HISTORIC AND DESIGN REVIEW COMMISSION

HDRC CASE NO: 2022-424
ADDRESS: 322 N HACKBERRY ST
LEGAL DESCRIPTION: NCB 584 BLK W 1-2 7 LOT W 108.33 FT OF 6 ARB A8
ZONING: RM-4, H
CITY COUNCIL DIST.: 2
DISTRICT: Dignowity Hill Historic District
APPLICANT: Noe Garcia/GARCIA MAGDALENA L & NOE A
OWNER: Noe Garcia/GARCIA MAGDALENA L & NOE A
TYPE OF WORK: Construction of a carport and rear accessory structure, exterior modifications, fenestration modifications
APPLICATION RECEIVED: August 04, 2022
60-DAY REVIEW: Not applicable due to City Council Emergency Orders
CASE MANAGER: Edward Hall

Historic and Design Review Commission
Design Review Committee Report

HDRC Case #: 2022-424

CARPORT EAST ELEVATION SC: 3/16" = 1' 0"

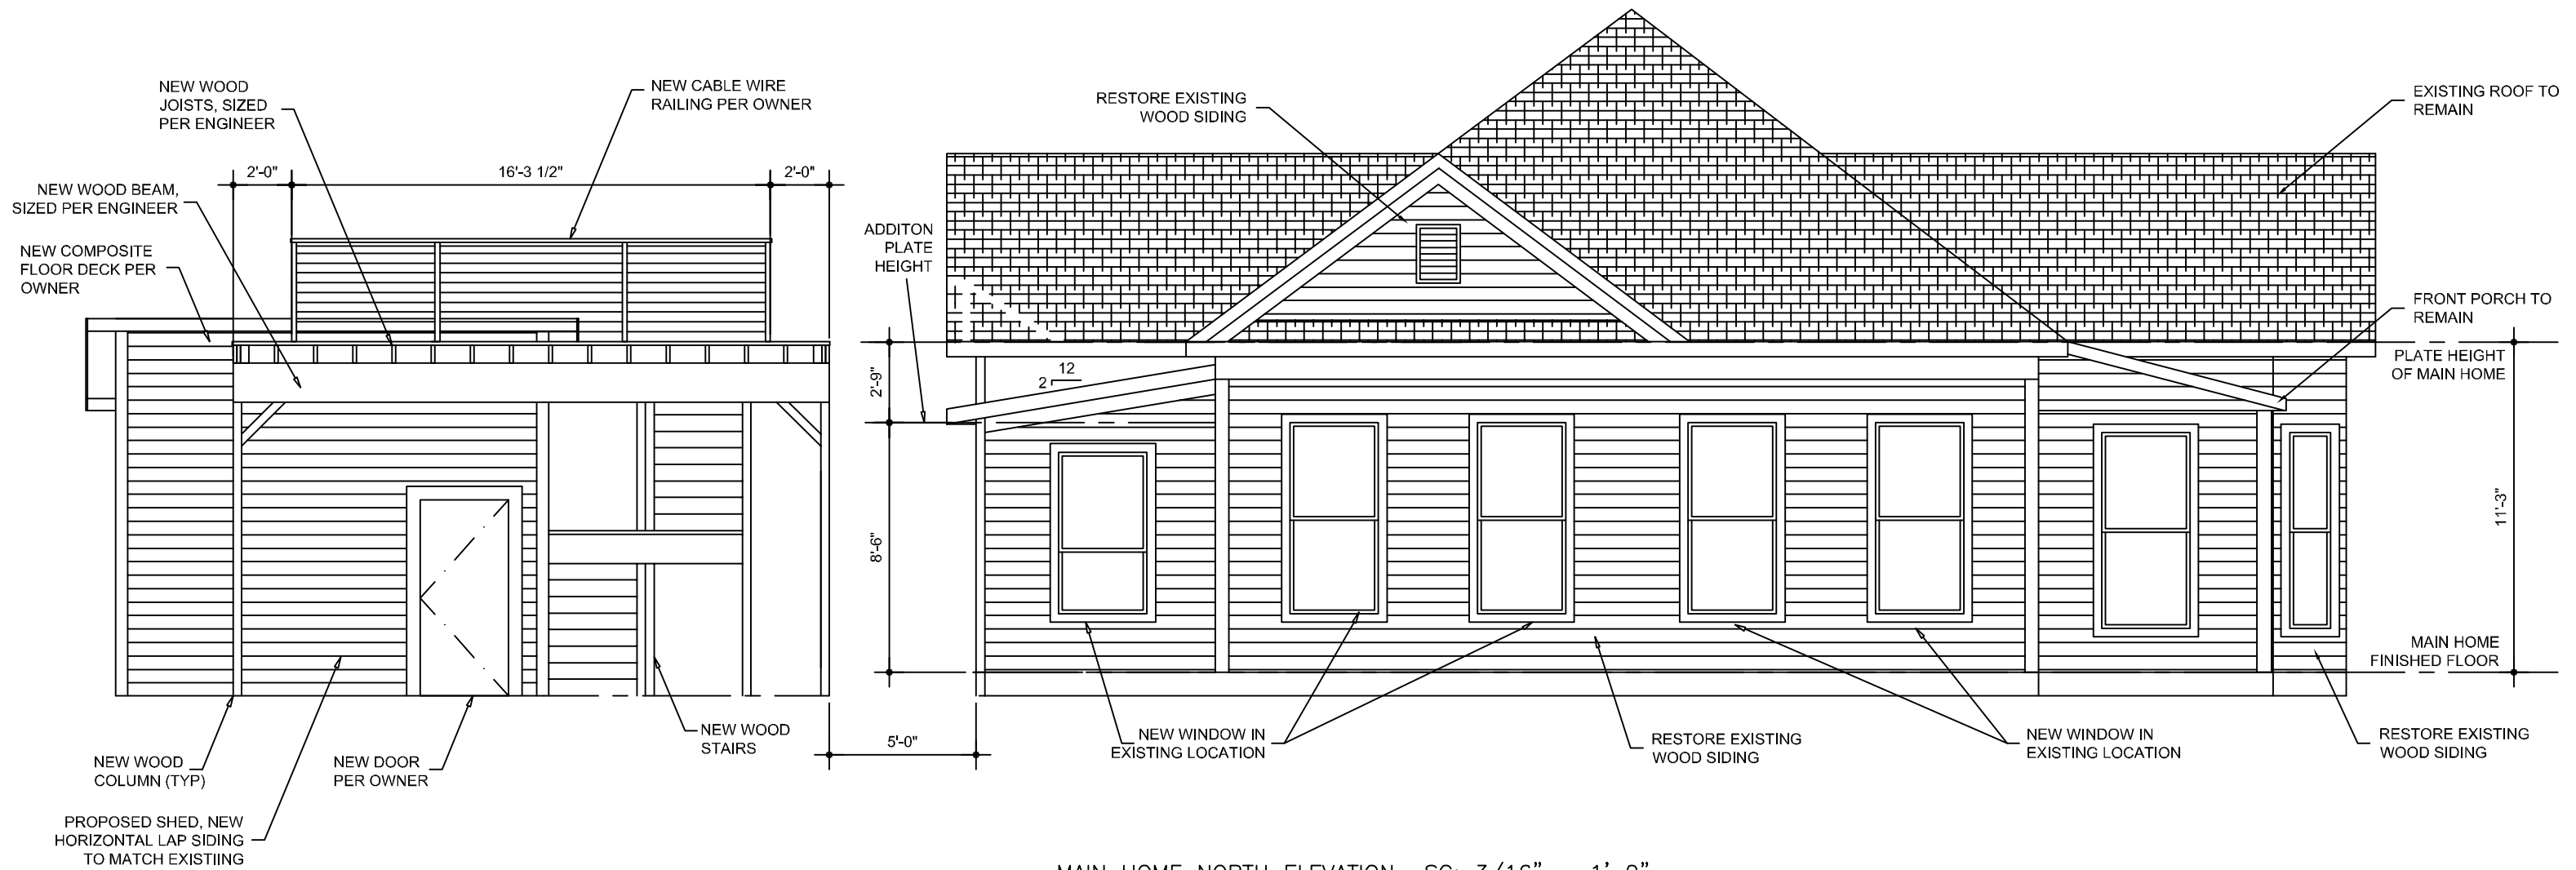
- f. **MASSING & FORM** – The applicant has proposed an overall height of approximately twelve (12) feet in height. Generally, staff finds the proposed height to be appropriate.

- h. **CHARACTER** – The applicant has proposed wood framing, wood siding and trim, a shed roof and wire cable railing. Generally, staff finds the proposed materials and character of the rear structure to be appropriate. Staff finds that wood framing with wire cabled would be more appropriate for the proposed railing than metal framing. The proposed door should be wood, to be consistent with those found historically on site.

- iii. That wood framing with wire cables be installed rather than railing with metal framing.
 - iv. That the proposed door be wood, to be consistent with those found historically on site.

MAIN HOME NORTH ELEVATION SC: 3/16" = 1' 0"

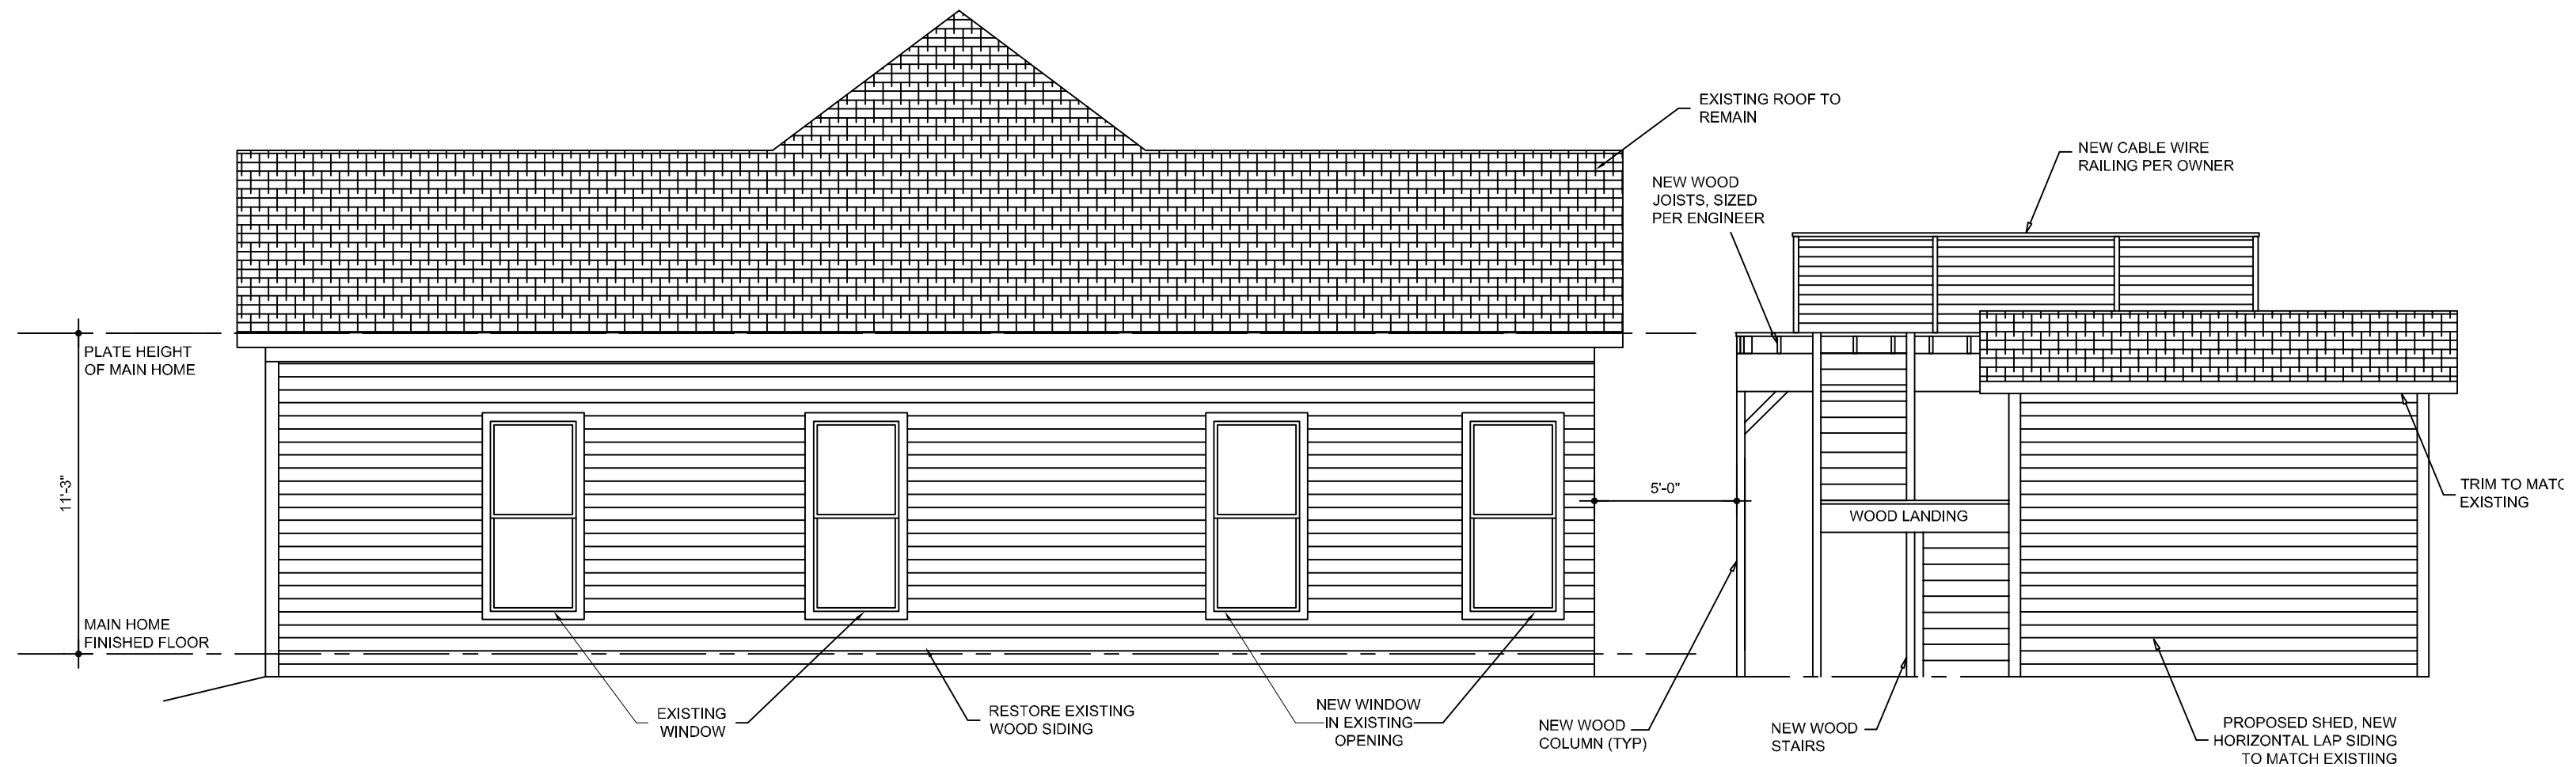
- j. **FENESTRATION RESTORATION** – The applicant has proposed to install windows in previously closed window openings on both the north and south facades. Staff finds this scope of work to be appropriate and consistent with the Guidelines. Staff finds that all new windows should be consistent with staff’s standards for replacement windows.

- 4. Staff recommends approval of item #4, the installation of windows in previously closed window openings on both the north and south facades based on finding j with the following stipulation:

- i. That all new windows should be consistent with staff’s standards for replacement windows.
